Coastal Access – Aust to Brean Down lengths ABD2 to ABD5 and ABD7 to ABD10

Representations with Natural England's comments

July 2020

Proposed modification to the route at Huckers Bow Sluice from the Disabled Ramblers (route sections ABD-6-S060 and ABD-7-S001)

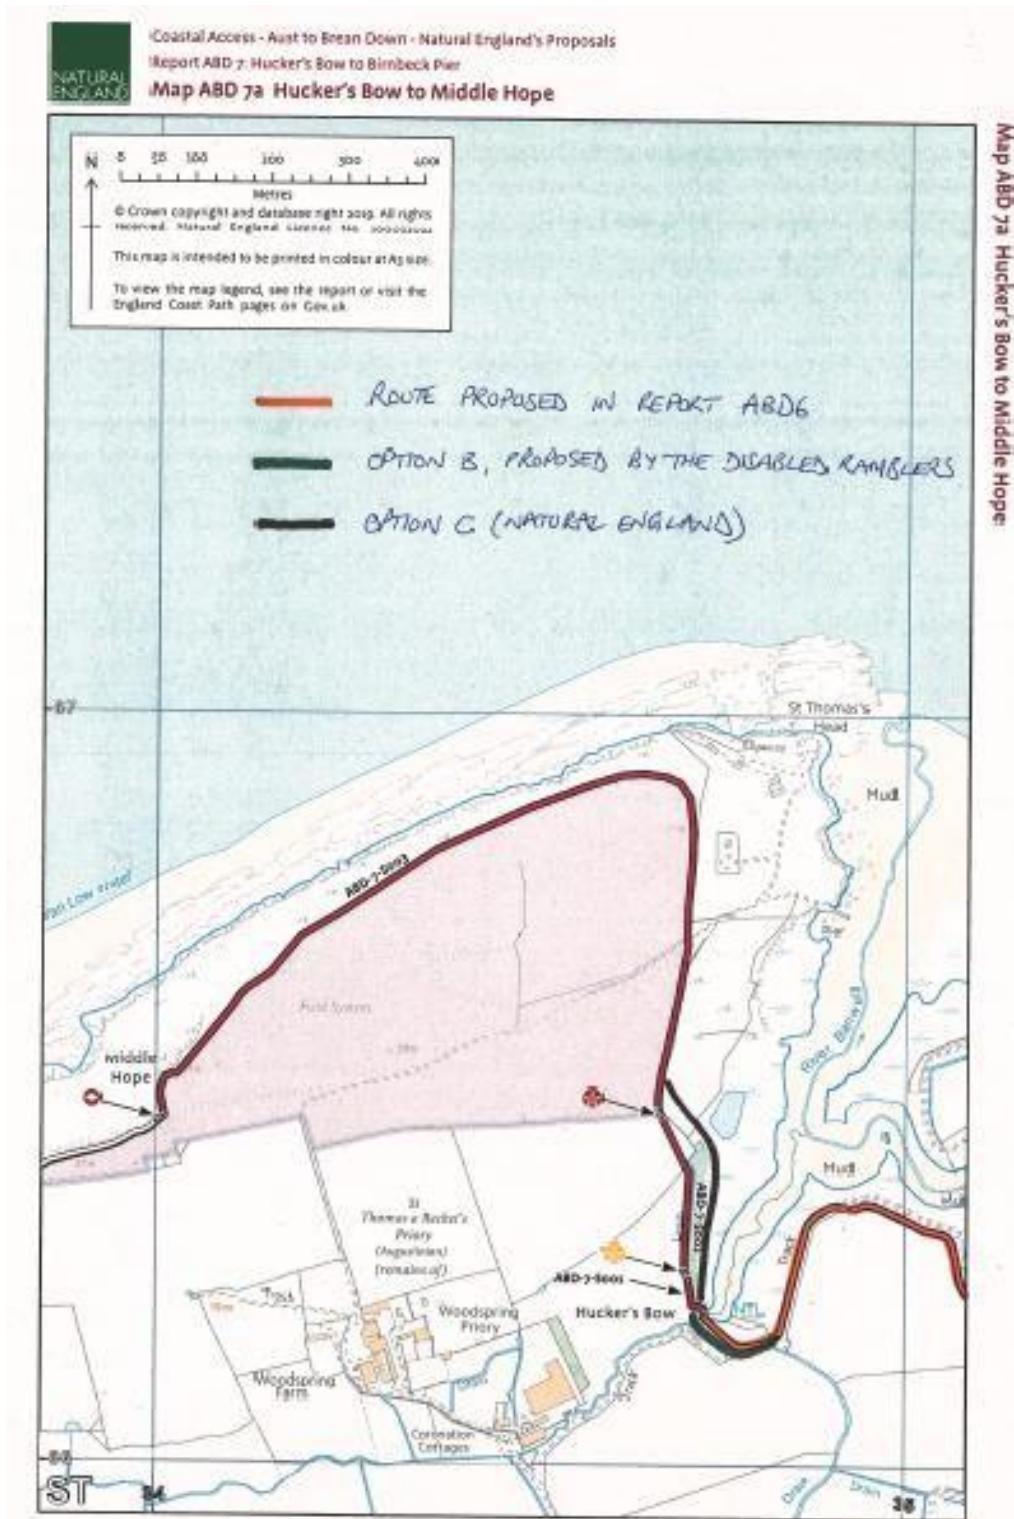
1. Drop down the track to the car park, using the outside of the bend which is otherwise quite steep.

2. Cross the car park aiming for the concrete pathway over the sluice (as indicated by the orange arrow).

3. The turns in the existing pathway over the sluice walls are too tight for mobility scooters (top), but with removal of the temporary fencing/gates scooters could cross more directly, as indicated by the blue and orange arrows (bottom).

The Disabled Ramblers propose a route modification at Huckers Bow sluice to allow access to Middle Hope for mobility scooter users. In section 5 below we include their photographs which illustrate the proposed modification. We also include a hand annotated version of report map ABD 7a to show its location (marked option B on the map). The map also shows the location of another route which we believe is also suitable for mobility scooter users (marked route C).

We do not consider it necessary for the Secretary of State to modify Natural England's proposed route, which follows the steps, to enable the desired access to Middle Hope for mobility scooter users. Instead, we recommend that [he] approve that route, noting that it is for Natural England and the local access authority to provide an alternative as part of the establishment works, for those who wish to avoid the steps.
